# Manual 11 Changes - Order 745 Concerns

MRC Sept. 27, 2012  
DR Supporters

# Example - 2 day span

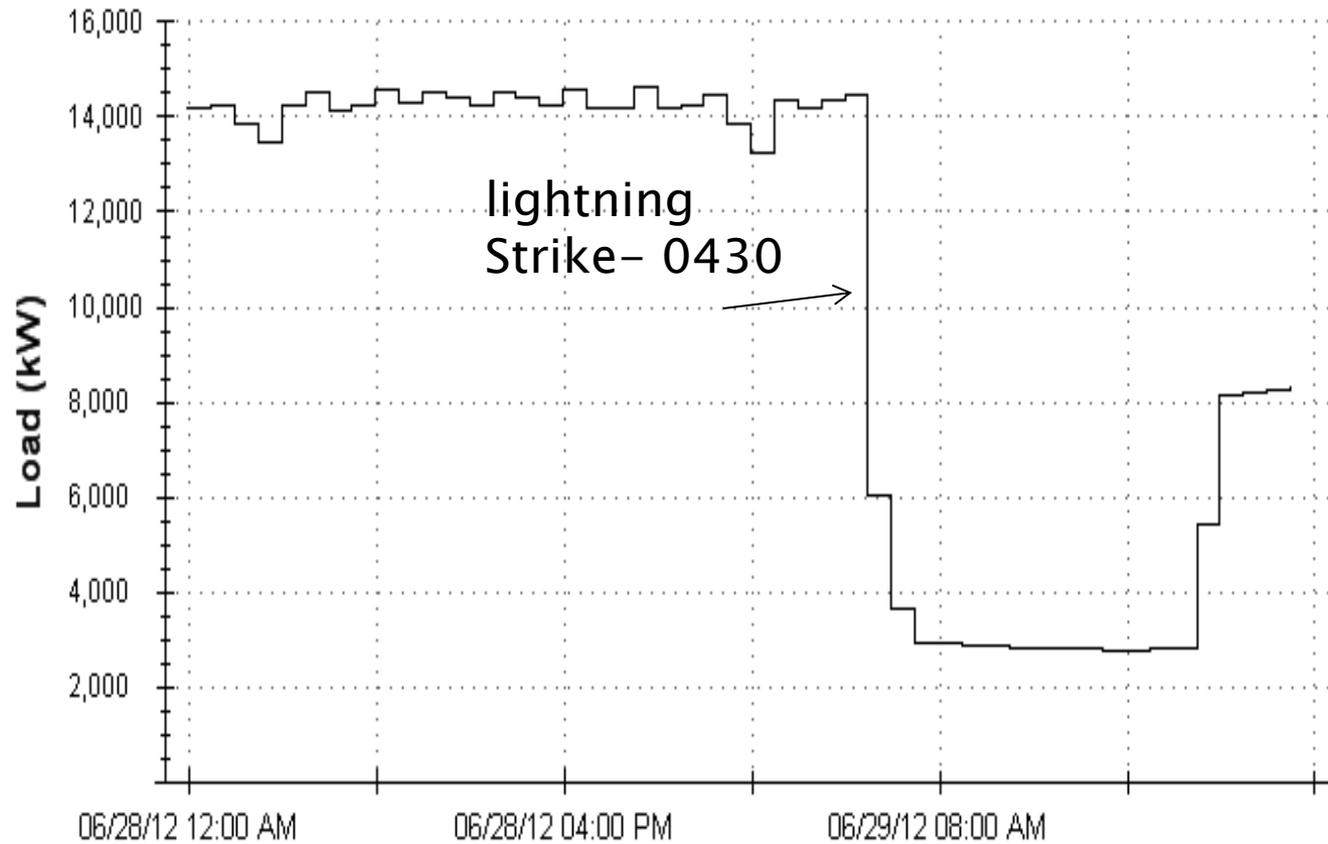
- ▶ Process is either ON or OFF.
- ▶ Process does not show daily or even weekly cycles as RRMSE is designed to address.
- ▶ Process does not exhibit daily variation in load cycles as SAA is designed to capture
- ▶ Process takes multiple hours of full electric demand before production is resumed.

# Example with SAA

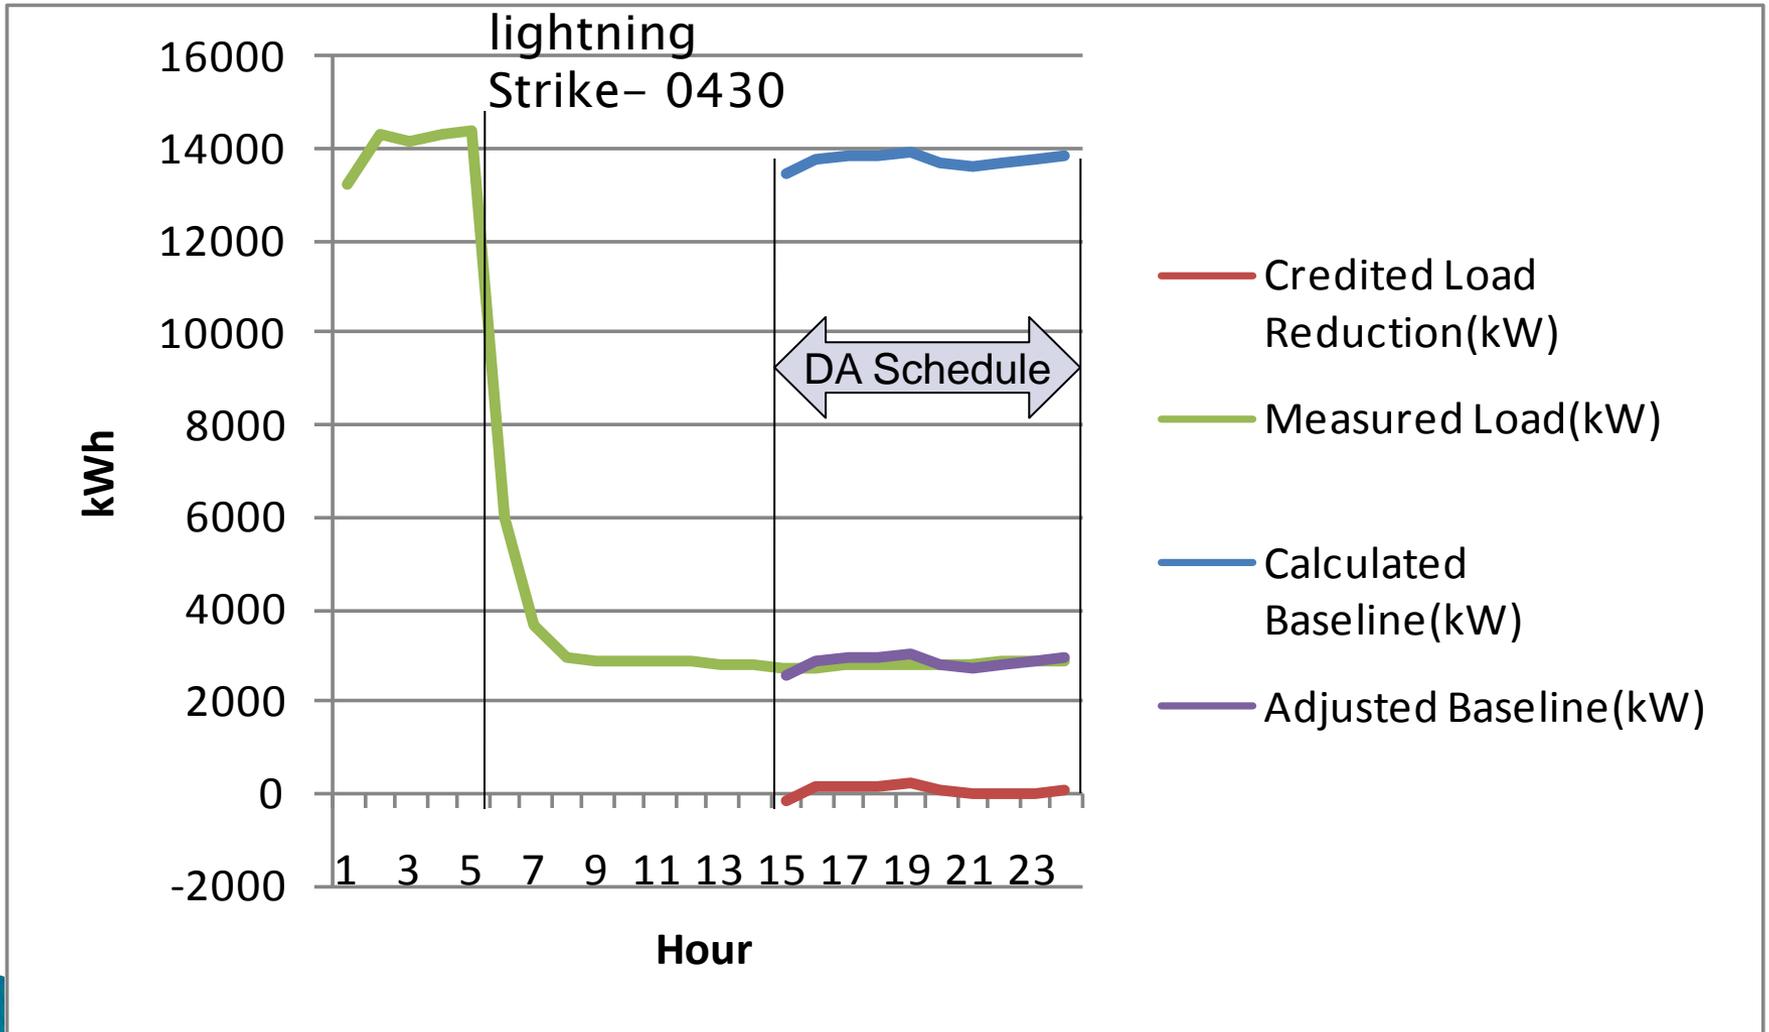
- ▶ For this customer, use of an SAA incents the customer to operate uneconomically in order to re-establish an appropriate baseline.
  - ▶ Depending on timing:
    - *Use of an SAA for this customer can incent the customer to NOT curtail – even when there is a DA commitment!*
    - SAA precludes credit for a curtailment – so why curtail?
-
